# D-PLCA Comment #47 Blocking Detection Of Own Transmitted Beacons

IEEE 802.3da Interim May 2025

# Timing of tx\_cmd and rx\_cmd

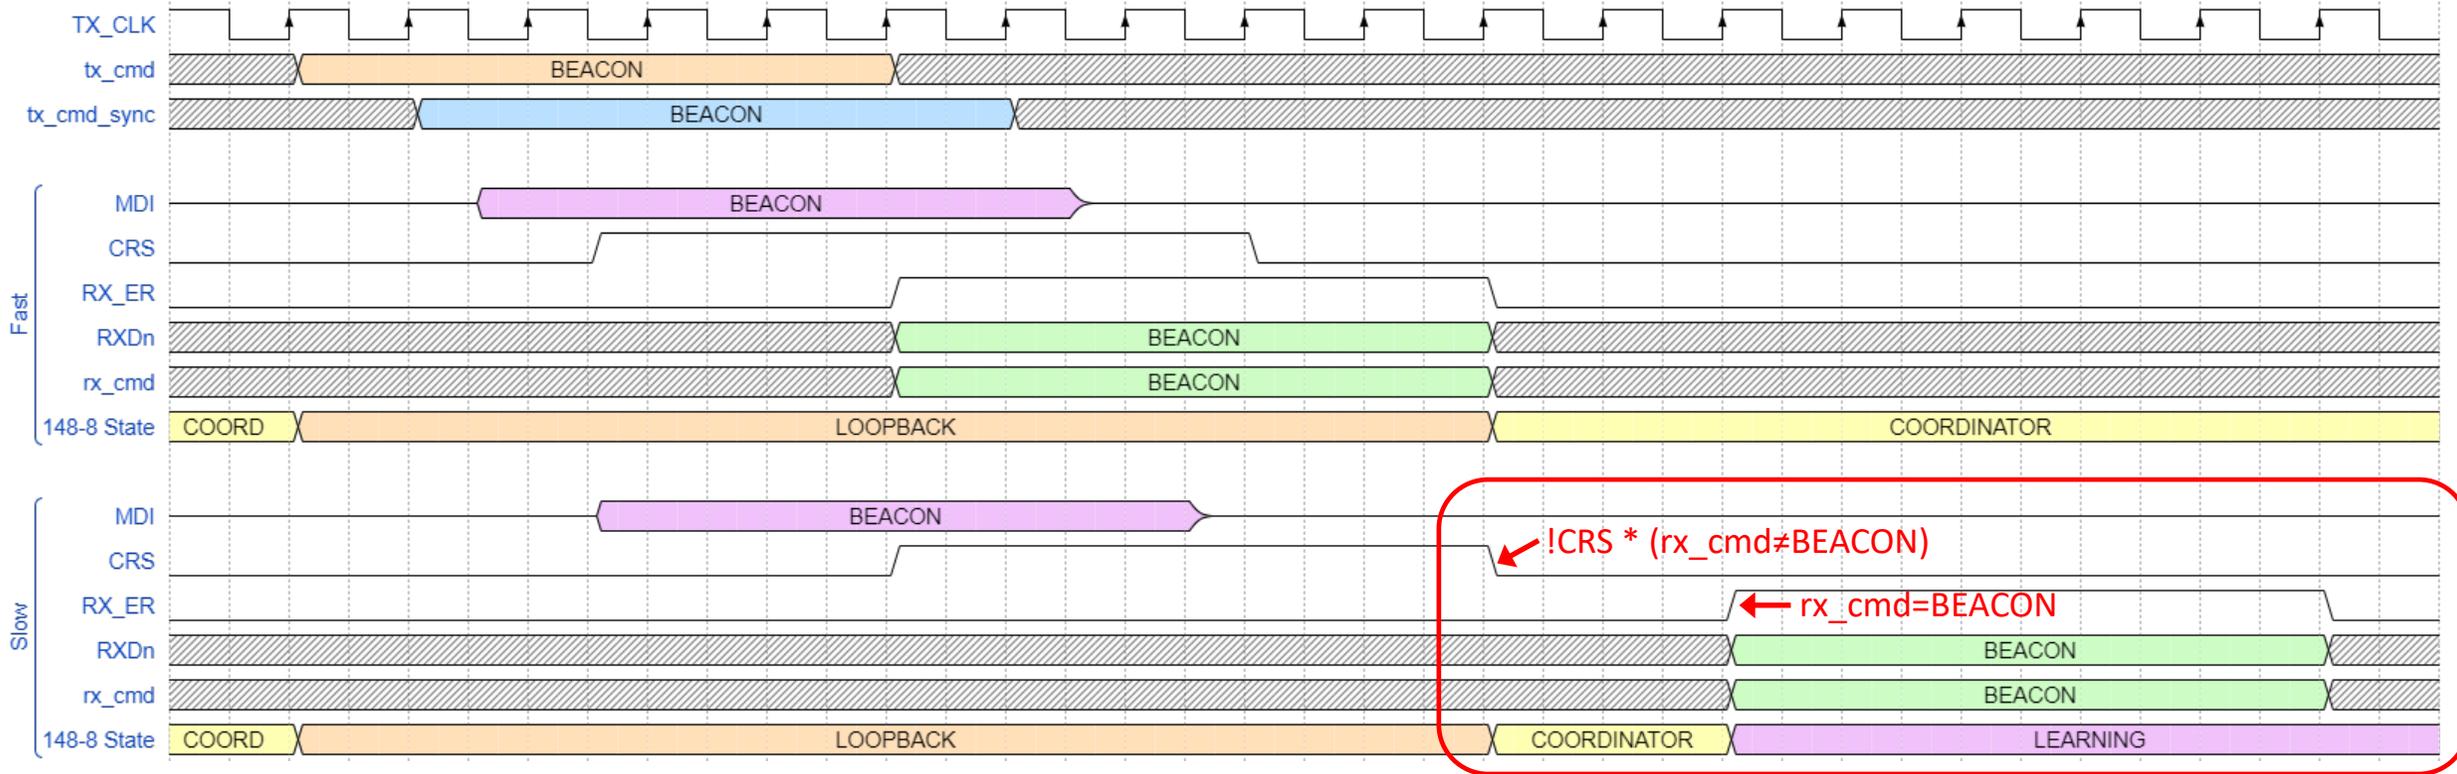
- Given the delay constraints in Clauses 147 and 188, the timing of rx\_cmd and CRS from tx\_cmd may vary significantly.
- At the slow end of the constraints, the current algorithm to block loopback reception of transmitted BEACONS will not work.
  - Carrier sense goes away before the BEACON is decoded and placed on the MII prematurely moving from LOOPBACK back into COORDINATOR
  - The BEACON is then decoded and on the MII (rx\_cmd=BEACON) causing incorrect transition from COORDINATOR to LEARNING

(Only the relevant portion of the D-PLCA Control State Diagram (Figure 148-8) shown)

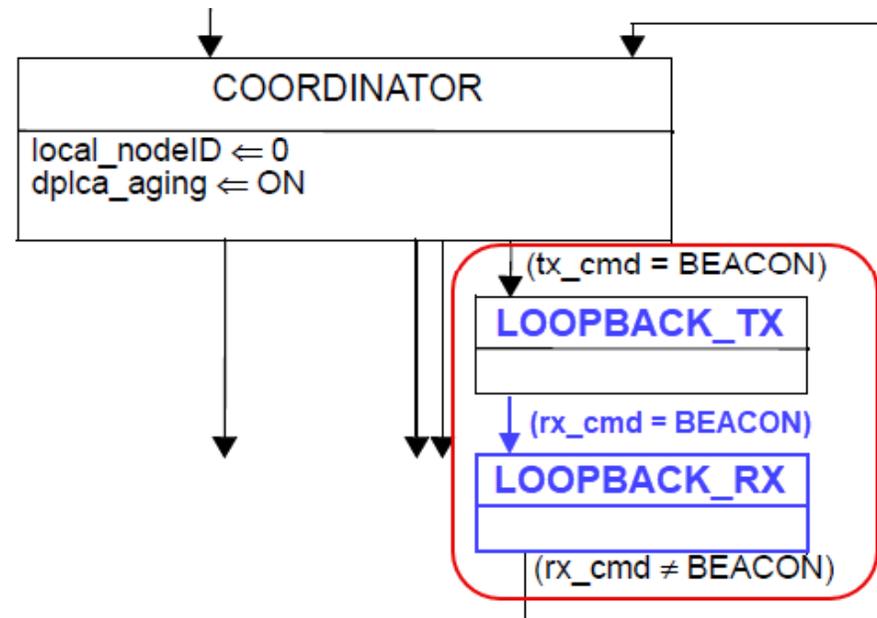
- **Use two loopback states:**

- The current loopback state is renamed LOOPBACK\_TX
  - Entered when a BEACON is being transmitted (tx\_cmd=BEACON)
- The new, second loopback state is LOOPBACK\_RX
  - Entered when the loopback BEACON is being detected (rx\_cmd=BEACON)
  - Exited to COORDINATOR when the loopback BEACON is no longer detected (rx\_cmd≠BEACON)

# Proposed solution - timing

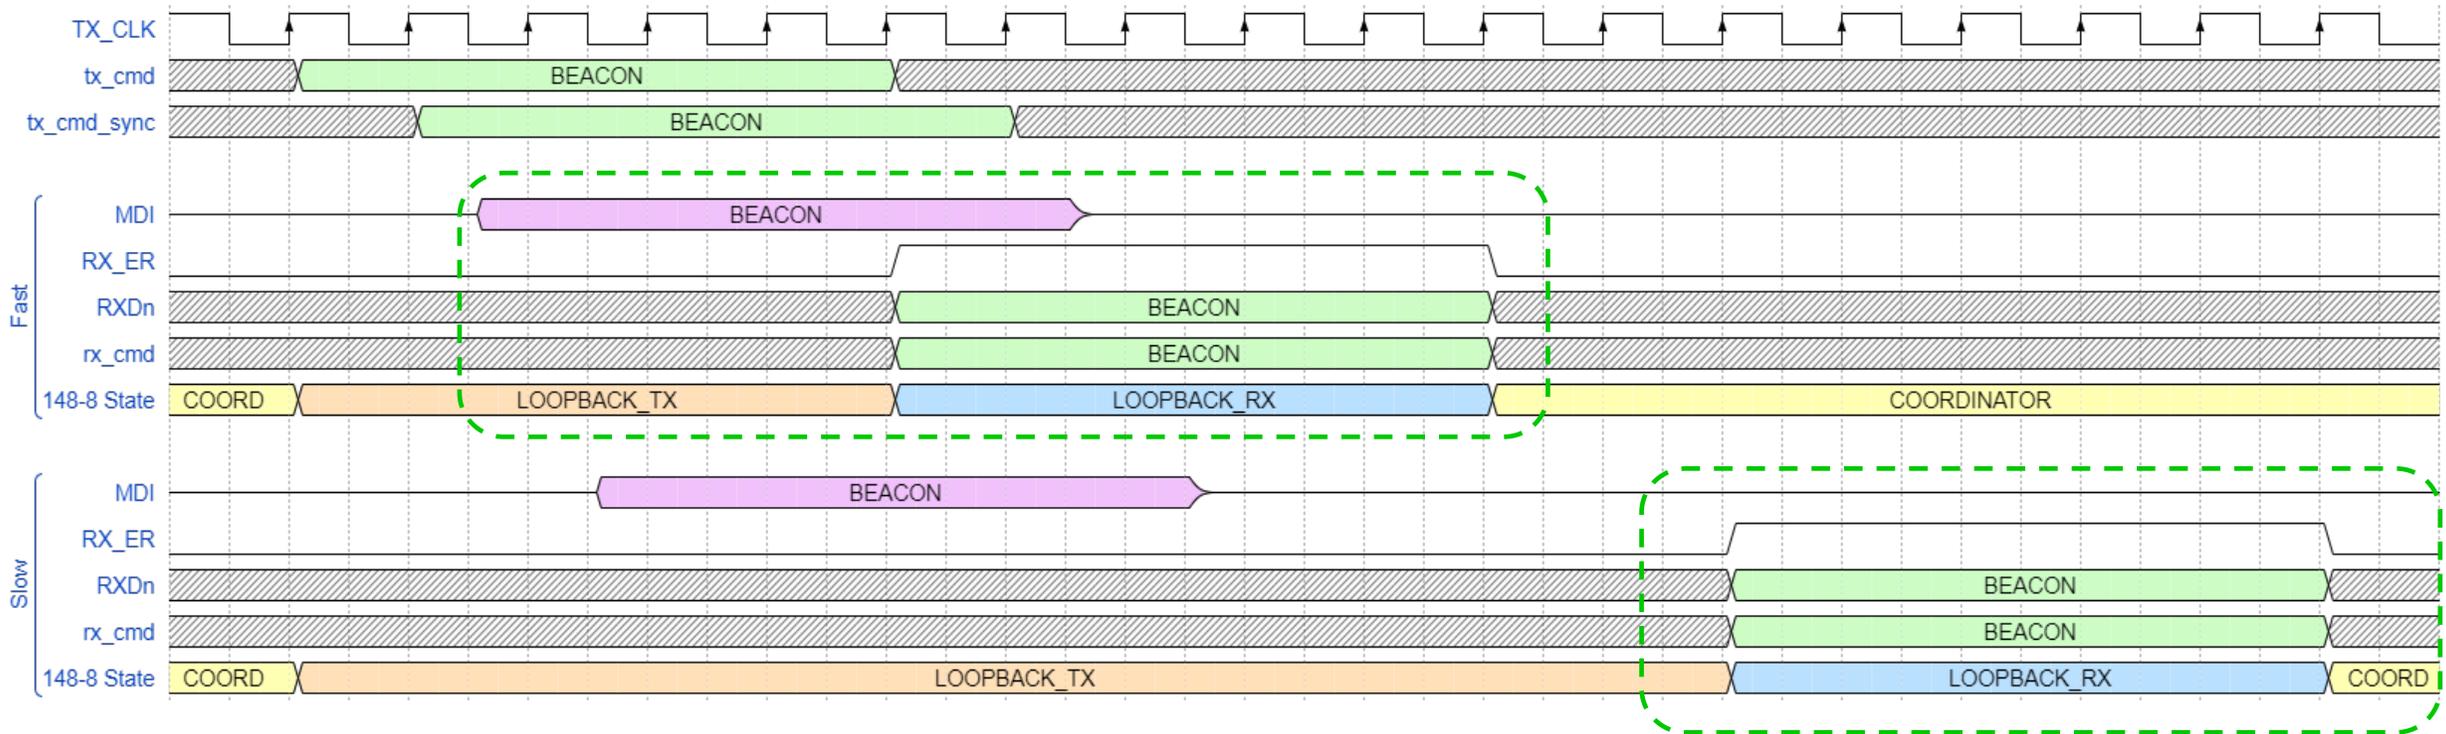
- Once command to transmit a BEACON starts, enter the LOOPBACK\_TX state
- Remain in LOOPBACK\_TX until the loopback BEACON is detected
- Enter and remain in the LOOPBACK\_RX state until end of loopback BEACON detection
- Once end of the loopback BEACON detection has ended, return to the COORDINATOR state
